Access Compliance Report

Public Rights-of-Way

(Curb Ramps)

Intersection ID: 12787	Main Street: BANDY_DR	Cross Street: PENCE_RD	Location: NW
ADA ID: 021BF5A8FBA1	Ramp Type: Combination2	Initial Pass/Fail: Fail	Overall Compliance: No
Codes/Mitigation Info/Possible Solution			Severity Score: 55
			Field Measurements/Component Compliance

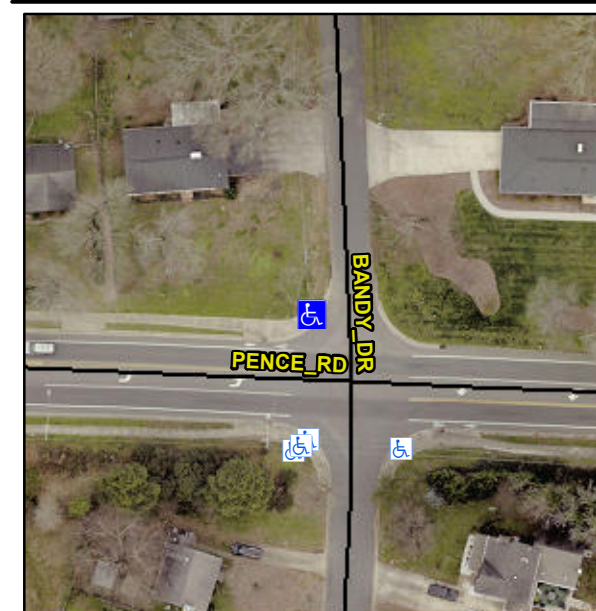
Not Found, R304.5.1, R304.5.3, R304.3.2

Compliance	Description	Data	Compliance	Description	Data
N/A	Ramp Length LT (in)	59.0	N/A	Ramp Length RT (in)	N/A
Yes	Ramp Width LT (in)	67.0	N/A	Ramp Width RT (in)	N/A
No	Ramp Slope LT (%)	13.9	N/A	Ramp Slope RT (%)	N/A
No	Ramp XSlope LT (%)	5.3	N/A	Ramp XSlope RT (%)	N/A
N/A	Ramp Length (in)	61.0	Yes	Ramp Slope (%)	8.0
No	Ramp Width (in)	32.0	No	Ramp XSlope (%)	5.2
N/A	Flare Type LT	N/A	N/A	Flare Type RT	N/A
N/A	Flare Slope LT (%)	N/A	N/A	Flare Slope RT (%)	N/A
N/A	Flare Traversable LT?	N/A	N/A	Flare Traversable RT?	N/A
N/A	Landing Length (in)	N/A	N/A	DWS Provided?	N/A
N/A	Landing Width (in)	N/A	N/A	DWS Contrast?	N/A
N/A	Landing Slope (%)	N/A	N/A	DWS Length (in)	N/A
N/A	Landing X Slope (%)	N/A	N/A	DWS Full Width?	N/A
N/A	Landing Curb? (Y/N)	N/A	N/A	DWS Offset (in)	N/A
N/A	Shared Landing?	N/A			
N/A	Gutter Ponding?	N/A	N/A	Gutter Slope (%)	N/A
N/A	Gutter Lip Ht (in)	N/A	N/A	Gutter X Slope (%)	N/A
N/A	Painted X Walk1?	No	N/A	Painted X Walk2?	N/A

Remove & Replace Entire Ramp.
